## Strafford Town Office

Reference: Structural Inspection of Strafford Town Hall Building

Reference: Structural Inspection of Strafford Town office Roof Damage  
227 Justin Morrill Highway, Strafford, Vermont

Reference: Structural Inspection of Strafford Town office  
227 Justin Morrill Highway, Strafford, Vermont

SSK-1

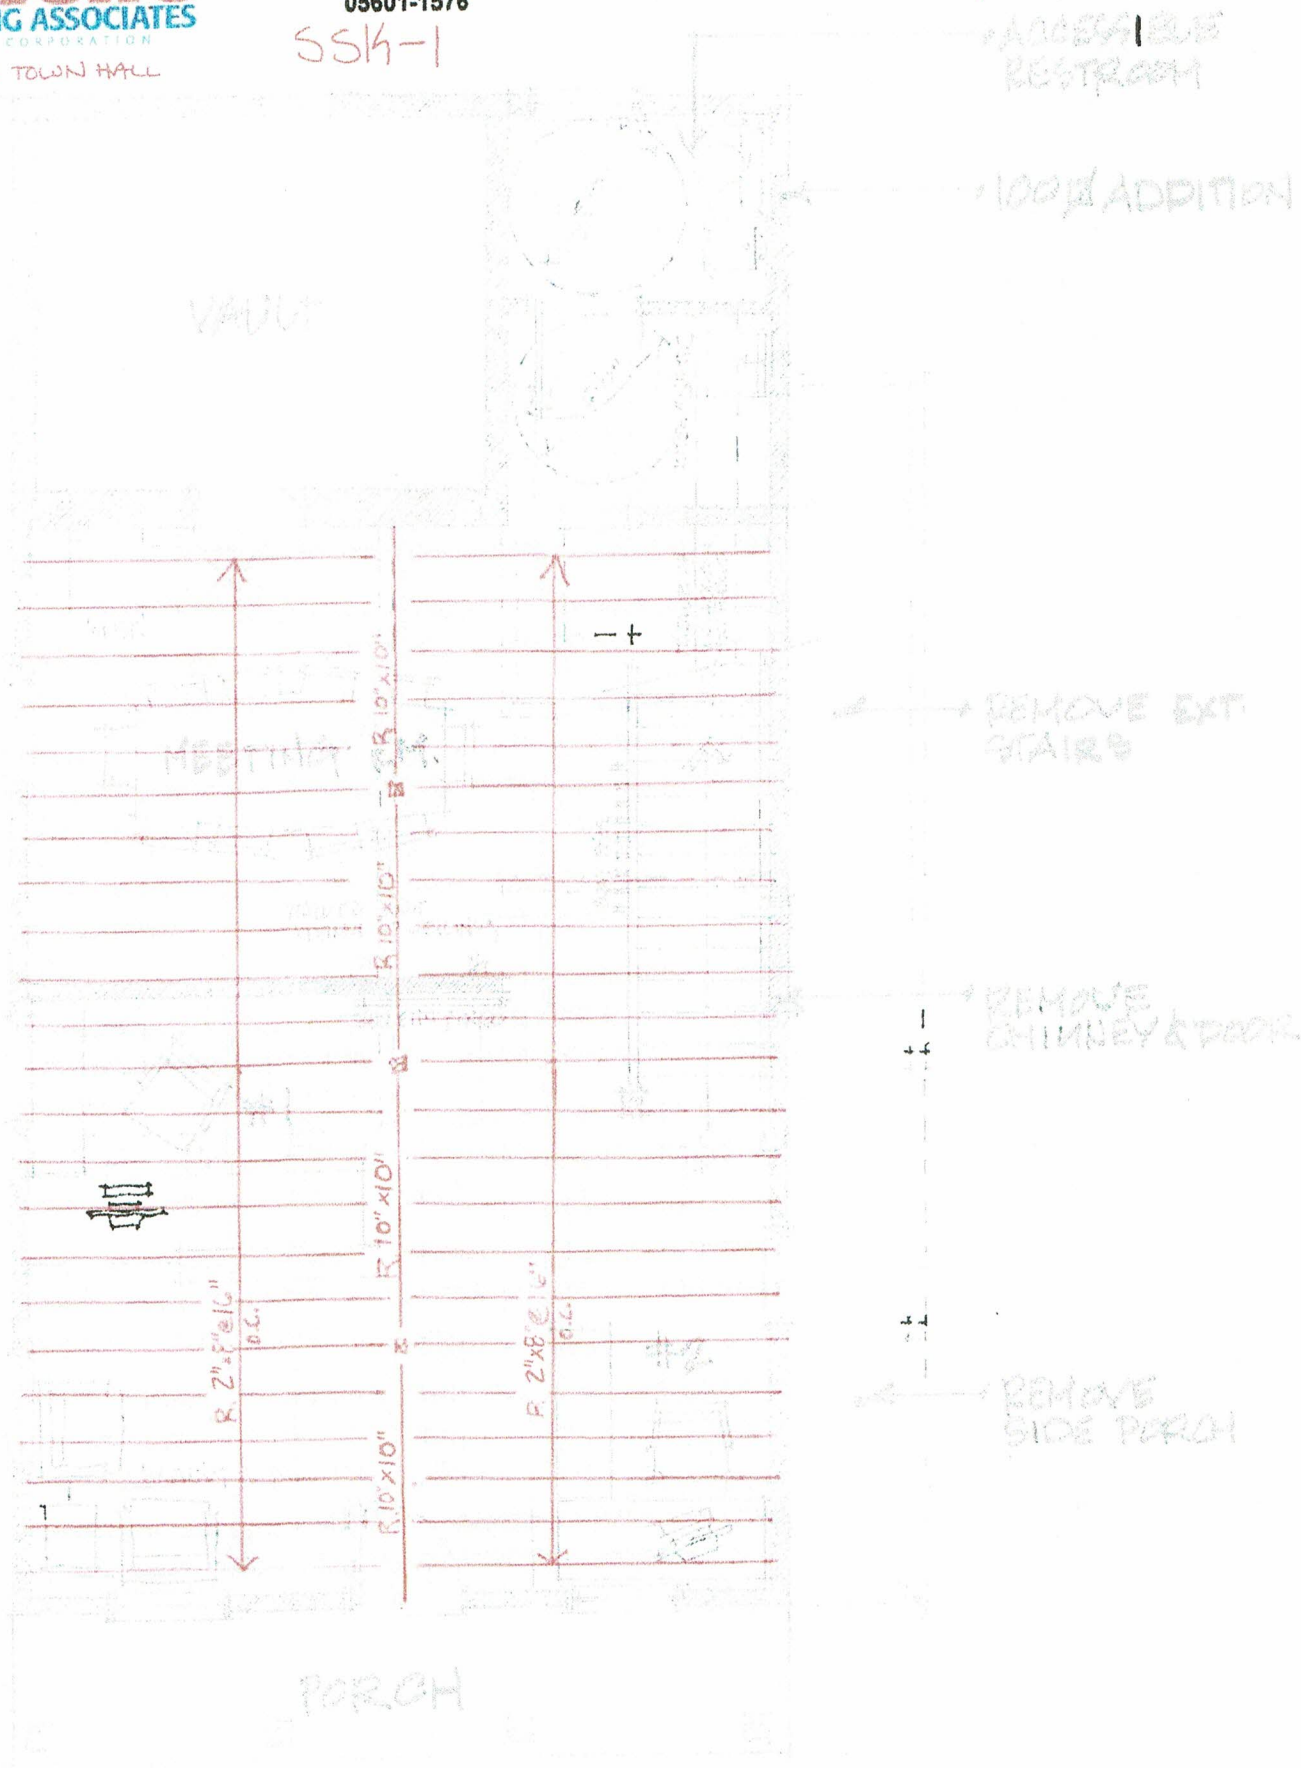
The first floor framing was partially exposed in the basement and the framing direction is shown in the attached SSK-1. The second floor framing was not exposed, but based upon nail patterns in the flooring and based upon visible columns in the first floor, we estimate the framing to be as shown in the attached sketch SSK-2. The roof framing could not be observed but based upon the shape of the second floor ceiling and roof, it appears that the roof is comprised of a tied rafter system that relies on the second floor framing to resist the outward thrust caused by the gambrel walls.

The first floor framing appears to be adequate for the expected floor loading but some rot was noted in the joists during the inspection. We recommend that a thorough inspection of the first floor framing be completed once adequate access is provided. Rotten members should be reinforced by sistering or replacement. Based upon our estimated thickness of the second floor framing and the estimated size and location of beams, we suspect that the existing second floor joists will be adequate for the expected use. The second floor beam will likely need to be reinforced especially if the existing post is relocated to create even longer spans. The addition of the stair opening will require reframing a portion of the floor to include the installation of new headers and trimmers around the opening. The installation of the stair will also require reinforcement of the interface between the roof and floor at the new opening. Preliminary assessment of the loads indicates that the reinforcements can be achieved with conventional or engineered lumber with some minor steel joinery. None of this reinforcement is beyond that expected in typical renovation work.

Photograph #1 – Roof damage

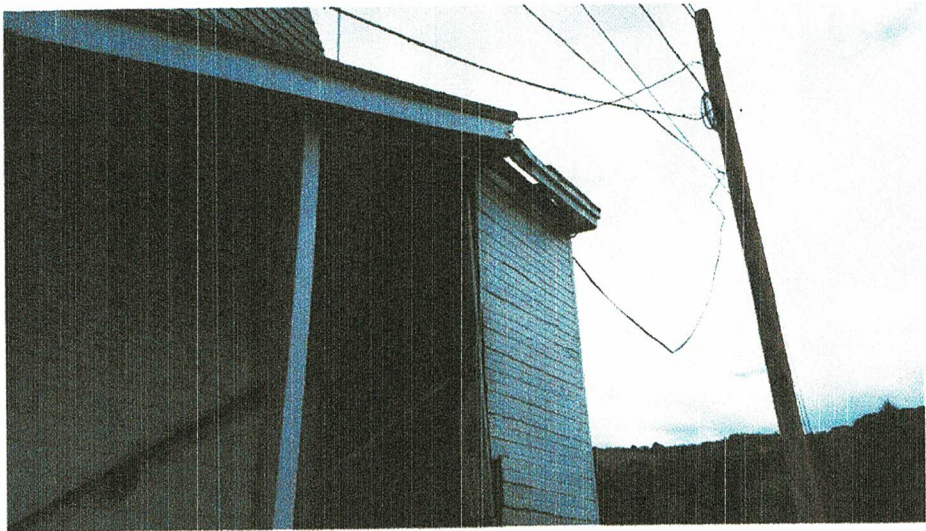
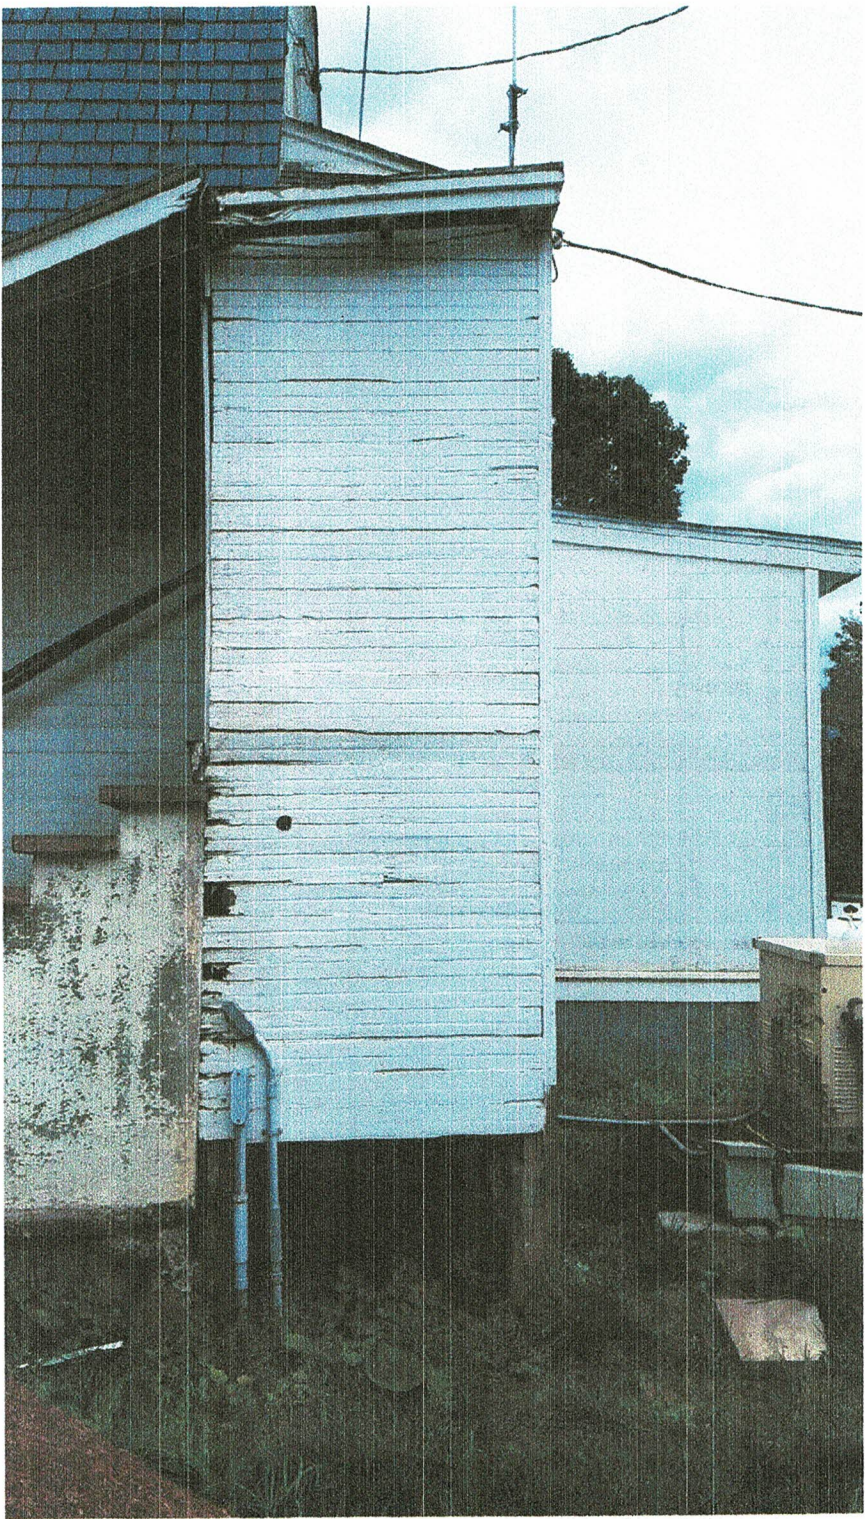
The damage to the stair and stair roof structure was isolated to the northwest corner of the structure (see photographs #1 thru #4). The pole damaged approximately 16 square feet of roofing, the roof sheathing in the corner of the building and the adjacent siding. In addition, the pole damaged one rafter and two supporting posts. As a result of the damage, we recommend that the repairs shown in the attached sketch SSK-1 be made to the building.

- Installation of three new 4x4 posts from foundation to roof structure
- Installation of new rafters
- Replace the existing T&G siding with new siding to match existing (we understand that future renovations are planned in this area. If desired a temporary sheathing such as T1-11 or a rail system could be installed in lieu of the T&G siding.)
- Replace existing T&G roofing with new T&G roofing (we understand that future renovations are planned in this area. If desired a less expensive sheathing such as 5/8" plywood could be installed in lieu of the T&G roofing.
- Repair the existing roofing.
- Replace any rotten framing discovered during installation of the new work in kind.
- Paint and finish the materials.

Photograph #1 – Porch post base rot

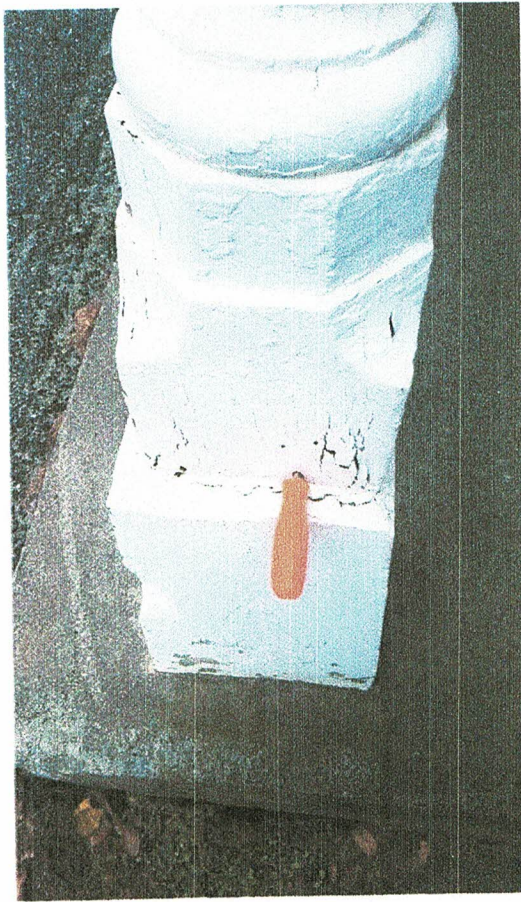
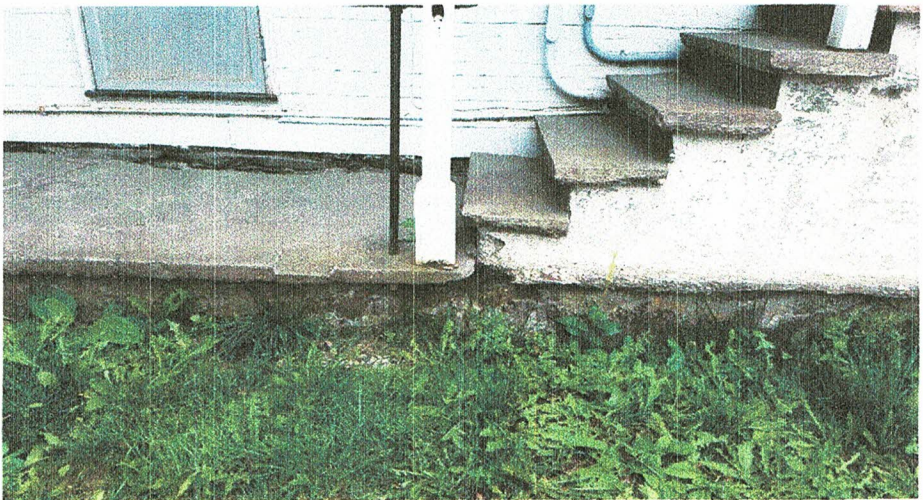
During review of the back-stair damage, I discovered that the north porch roof and the slab supporting it had both visibly degraded since my 2019 inspection. In my July 19, 2019 report concerning the building, the north porch was already in poor condition but at that time the porch was planned to be removed. The porch has continued to degrade and several of the posts are damaged and the exterior stair has continued to settle. In addition, grade against the building has been changed and as a result, water from a significant surface area is directed into the crawlspace. In our 2019 report we had recommended that the northern slab be removed and proper drainage provided to prevent further rot and water infiltration into the crawlspace. The current condition has made the crawlspace infiltration worse and has likely exacerbated rot and moisture conditions that already existing in the crawlspace.

In addition to the north porch issues, the eastern entry porch has also degraded since my 2019 visit. Currently the porch posts have severe base rot and the front porch slab is heavily cracked. Furthermore, the sills and siding are buried below the front porch slab. Based upon the insertion of probes along the entry, it appears that sill rot has gotten significantly worse since the 2019 condition. In addition, it appears that regrading of the road shoulder to the northeast has directed additional water towards the porch, sill, and crawlspace.

- Regrade the site to direct surface water away from the building.
- Repair/replace the existing damaged/rotten porch posts.
- Replace the existing foundation of both the eastern and northern porches.
  - The base slab at the bottom of the northern porch stair requires immediate attention.
- Repair/replace/reinforce the existing sills along the north and east walls of the building.

Building Section

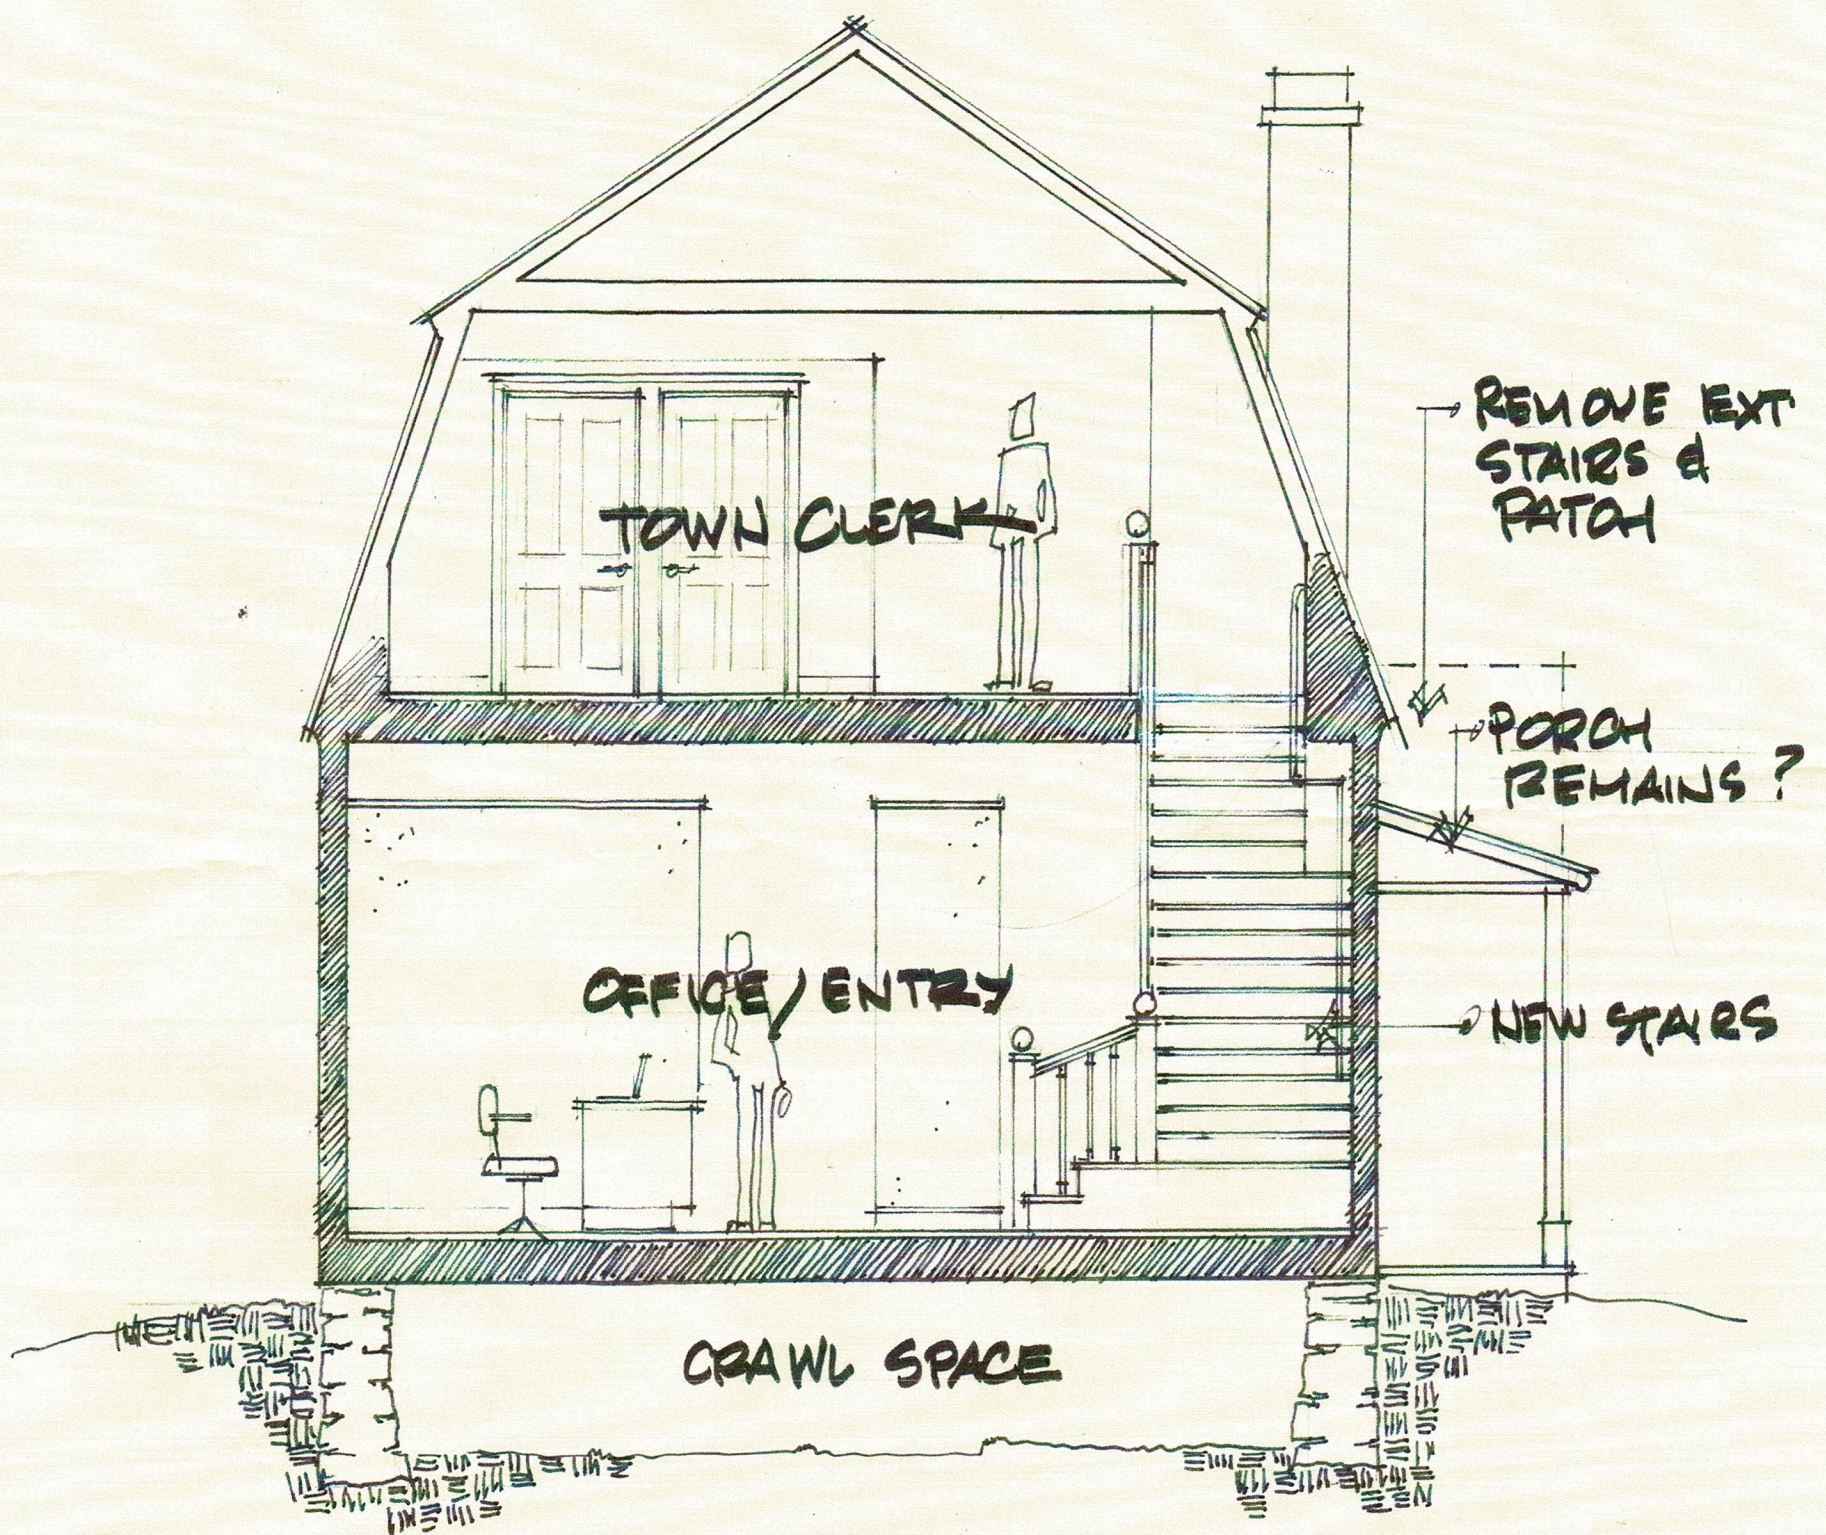
TDM: THIS IS FROM 2019 STUDY AND SHOWS  
SECTION THRU BUILDING. DISREGARD  
STAIR - STAIR IS NOW ANTICIPATED IN  
ADDITION
